FW: Fence Ordinance

From: Tyson Glover <tysonglover@riverheights.org>
Sent: Friday, November 18, 2022 1:30 PM
To: Blake Wright <blakewright@riverheights.org>; nhcooley@comcast.net
Cc: Jason Thompson <jasonthompson@riverheights.org>; Janet Mathews <janetmathews@riverheights.org>; Sharlie Gallup <sharliegallup@riverheights.org>; Chris Milbank <chrismilbank@riverheights.org>
Subject: Fence Ordinance

Figure 10-12-3 Corner Lot Fencing Requirements

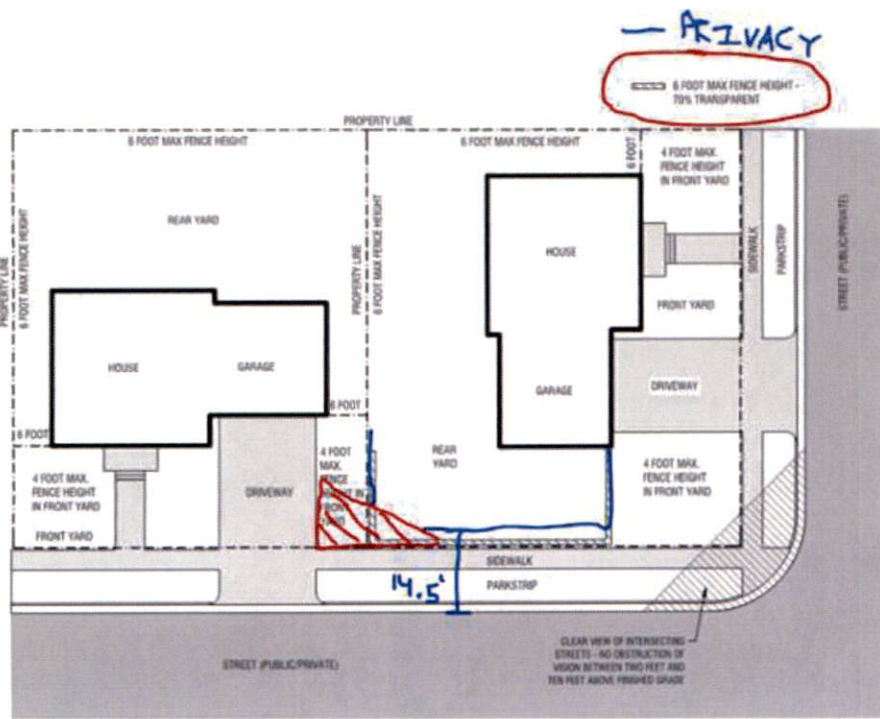
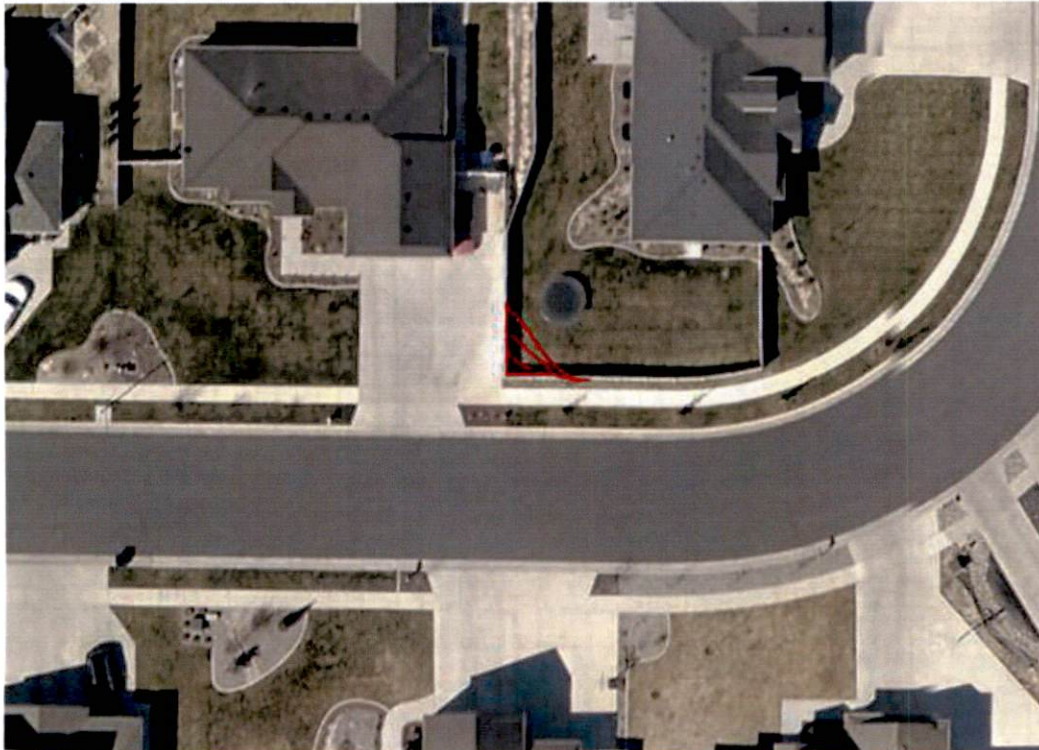
A good example of #1 is a fence installed in Saddlerock at 947 E 480 S. I'm friends with the landowner and have been told that it was approved by Blake and the previous Mayor prior to installation. I recommend we discuss including driveway approaches into 10-13-15, "Clear View of Intersecting Streets". Figure 10-12-3 shows the 70% transparency fencing allowed on the property line, but does not mention anything for the solid 6' fencing that is offset 14.5' from the pavement as shown:

I expect that our intent is to not allow any solid fencing within site triangles by drive approaches (Red hatch area), and that we might want to update our figure to reflect that. Here is an as-built fence that is in compliance with the current code, and has a solid 6' fence installed adjacent to a driveway:

other small vertical protrusions not more than ## inches in diameter shall be permitted within the clear-view area." We need to preserve the sight triangle to allow drivers time to react to children or other pedestrians leaving the driveway.

Proposed language could read, "Obstruction of vision within ten feet of intersection of a private drive with a city right-of-way will not be permitted. Trunks of trees, open-work fences at least 70 percent transparent, light or telephone poles or
